Re: Peer Review Comment Response  
444 East Central Street, Franklin, MA

Goddard Consulting, LLC, (Goddard) is pleased to submit this response letter on behalf of TAG Central LLC (the Applicant), to provide responses to the Peer Review Comment Letter dated 2/24/25 issued by BETA Group, Inc. regarding the Abbreviated Notice of Resource Area Delineation (ANRAD) application filed for 444 East Central Street.

**Photo 1.** 1961 Aerial showing cleared site.

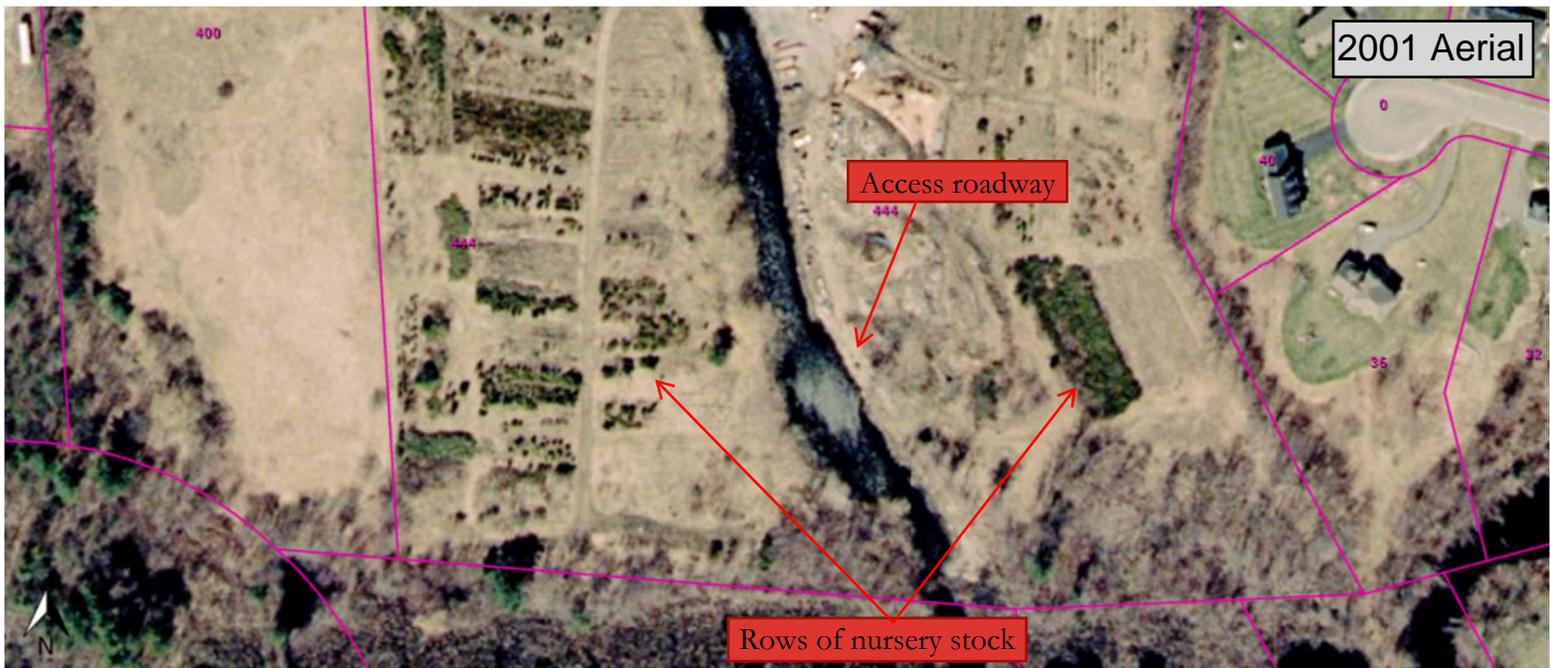
It is believed that the compost pile in question was placed in its location in approximately 2005, and its placement did not result in wetland fill; however, it was not permitted under an Order of Conditions. It is the understanding of the Applicant and the opinion of Goddard that the D-series IVW has always been isolated and was not made isolated by the placement of fill/compost. The site has a history of disturbance as seen in the attached Historic Aerial Imagery Exhibit. The first evidence of disturbance due to use as a nursery can be seen in the first exhibit taken in 1961. The site appears to be cleared in the aerial. The following aerial taken in 2001 clearly displays evidence of site clearing, a vehicle roadway along the now delineated A-series BVW, and rows of planted trees. In the 2008 exhibit the fill/compost pile is now visible from the aerial photograph along with the roadway. The 2021 aerial shows the site beginning to revegetate with a roadway intact still in use and the now vegetated fill/compost pile.

**Photo 5.** Berm and standing water within the D-Series IVW.

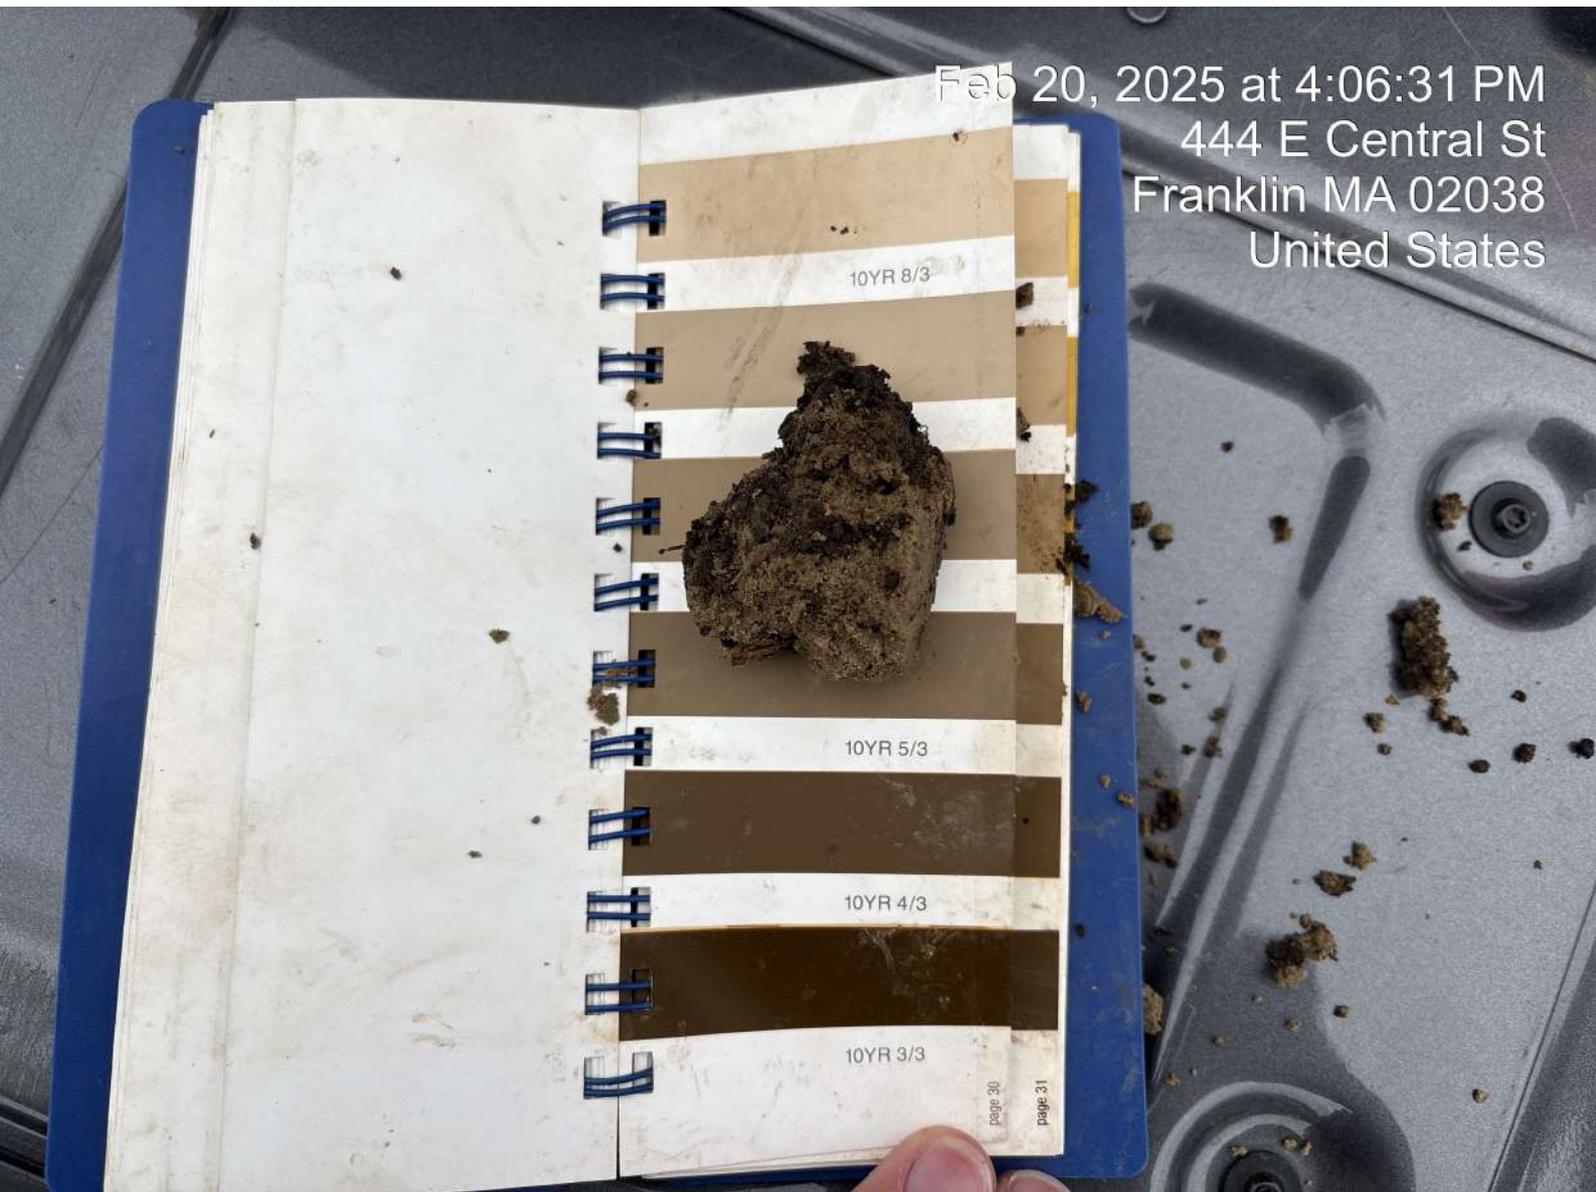
Photo 4 shows a row of planted yews on the northern side of the fill pile near the D-Series IVW. These plantings are holdovers from the site’s use as a nursery as displayed in the historic aerial exhibit. In this photo, the compacted roadway is also visible. It is Goddard’s opinion that the fill/compost pile is the leftover material from the clearing of the roadway and nursery which was then pushed into the upland area adjacent to the BVW. Photo 5 shows a constructed berm as a result of the fill/compost pile that can be seen near the IVW. The berm created by the fill/compost pile appears to have obstructed the natural movement of water downgradient toward the BVW, which

has impounded water and likely caused the creation of the IVW. The site topography pitches downgradient in this area from the nursery development toward the BVW.
